Access Compliance Report Public Rights-of-Way (Curb Ramps)

Main Street: N/A Cross Street: WINDMILL_AVE Location: SW

ADA ID: RPRK211110114210 Ramp Type: Type 4 - Parallel Initial Pass/Fail: Pass Overall Compliance: No Severity Score: 20

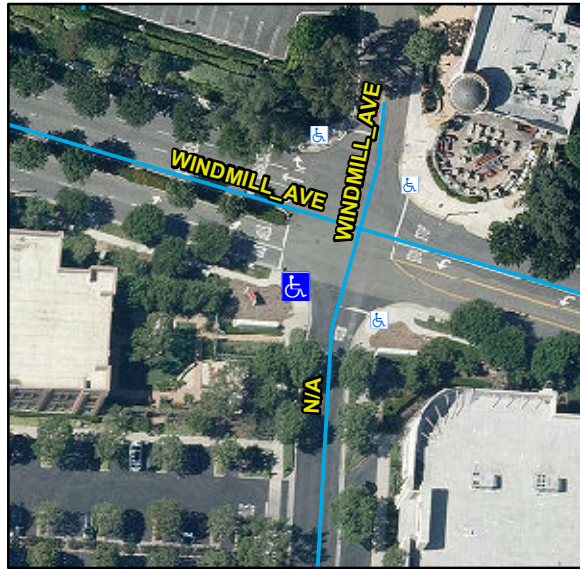
Compliance	Description	Data	Compliance	Description	Data
N/A	Ramp Length LT (in)	143	N/A	Ramp Length RT (in)	132
Yes	Ramp Width LT (in)	89	Yes	Ramp Width RT (in)	89
Yes	Ramp Run Slope LT (%)	2.2	Yes	Ramp Run Slope RT (%)	5.4
Yes	Ramp Cross Slope LT (%)	1.7	Yes	Ramp Cross Slope RT (%)	1.4
N/A	Landing Present	No	No	DWS Provided	No
N/A	Landing Length (in)	N/A	N/A	DWS Contrast	N/A
No	Landing Width (in)	N/A	N/A	DWS Length (in)	N/A
No	Landing Run Slope (%)	N/A	N/A	DWS Full Width	N/A
No	Landing Cross Slope (%)	N/A		DWS Offset Type	N/A
N/A	Landing Movement Obstructed?	No	N/A	DWS Offset Left (in)	N/A
	Landing Movement Type	Curb	N/A	DWS Offset Right (in)	N/A
N/A	Landing Shared	N/A			
N/A	Clear Space	Yes			
N/A	Clear Space To Crosswalk (in)	48			
N/A	Marked Crosswalk 1	No	N/A	Marked Crosswalk 2	No
	Crossing 1 Direction	E		Crossing 2 Direction	N
N/A	Marked Crosswalk 1 Width (in)	N/A		Marked Crosswalk 2 Width (in)	N/A
N/A	Ramp Inside Crosswalk 1	N/A	N/A	Ramp Inside Crosswalk 2	N/A

Crossing 1 Slope (%)	2.5		Crossing 2 Slope (%)	2.6
	Crossing 1 Cross Slope (%)	0.3		Crossing 2 Cross Slope (%)	0.3
Yes	Gutter Ponding	No	No	Curb Slope	9.5
Yes	Gutter Lip Height (in)	0		Road Run Slope (%)	0.2
Yes	Gutter Run Slope (%)	0		Road Cross Slope (%)	3.1
Yes	Gutter Cross Slope (%)	1.5	No	Perpendicular Joint Present	No
Yes	Overall Surface Condition	Acceptable			
	Cross Gutter Present?	No		Spandrel Present?	No
	Replace Cross Gutter?	N/A		Replace Spandrel?	N/A

Remove & Replace Curb Ramp With Two New Directional Ramps or Equivalent.
